Program Bulletin

CUSTOMER SATISFACTION PROGRAM

SUBJECT: Pinion Nut Improperly Fastened

MODELS: 2014 Chevrolet Silverado 1500
2014 GMC Sierra 1500
Equipped with 3.73 Rear Axle Ratio (GT4) and Locking Rear Differential (G80)

3661113

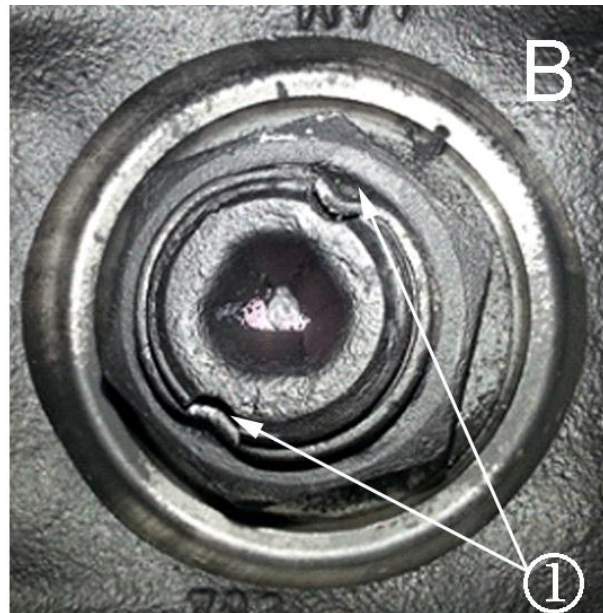
1. Place transmission gear selector in 'N' neutral.
2. Raise and support the vehicle. Refer to *Lifting and Jacking the Vehicle* in SI.
3. Determine if there is access to manually stake the two sides of the drive pinion nut lip to the corresponding grooves in the drive pinion gear without disconnecting the propeller shaft from the axle flange. A hammer and punch are required to manually stake the two sides of the drive pinion nut lip to the corresponding grooves in the drive pinion gear.

- If there is access to manually stake the two sides of the drive pinion nut lip to the corresponding grooves in the drive pinion gear WITHOUT disconnecting the propeller shaft from the axle flange, proceed to step 4.

- If there is NOT access to manually stake the two sides of the drive pinion nut lip to the corresponding grooves in the drive pinion gear, reference mark the rear propeller shaft to the rear axle pinion yoke BEFORE disconnecting the propeller shaft from the axle flange. Secure the end of the propeller shaft with a strap after disconnecting the propeller shaft from the axle flange. Proceed to step 4.

3661112

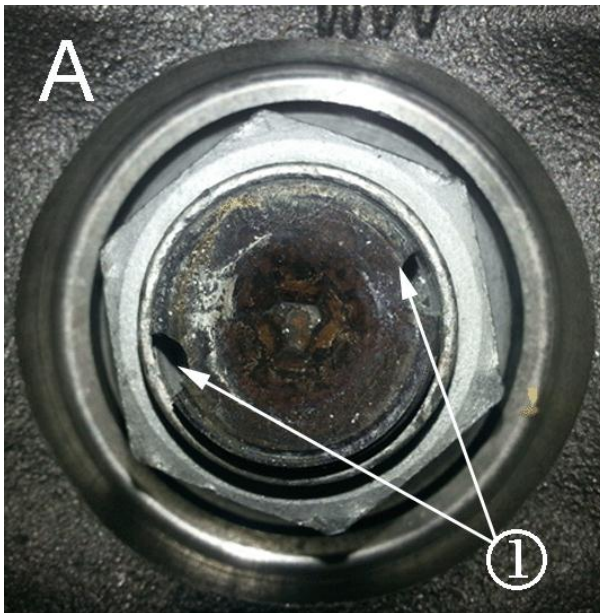
(A) No Staking (B) Acceptable Staking

Caution: Take care to not split the pinion nut lip. Splitting the pinion nut lip may affect pinion nut torque retention. Replace the pinion nut if the lip is split.

- Determine if the drive pinion nut lip (1) has been manually staked to the corresponding grooves in the drive pinion gear.
 - If the drive pinion nut lip (1) has NOT been staked, use a hammer and 5 mm (0.197 in) wide punch with a 1.8 mm (0.070 in) radius end to manually stake the two sides of the drive pinion nut lip (1) to the corresponding grooves in the drive pinion gear.
 - If the drive pinion nut lip (1) has been staked, use the punch to further stake the pinion nut into the two grooves.

Note: A 5 mm (0.197 in) wide punch with a 1.8 mm (0.070 in) radius end must be used to complete step 4. Modify a 5 mm (0.197 in) wide punch to include a 1.8 mm (0.070 in) radius end.
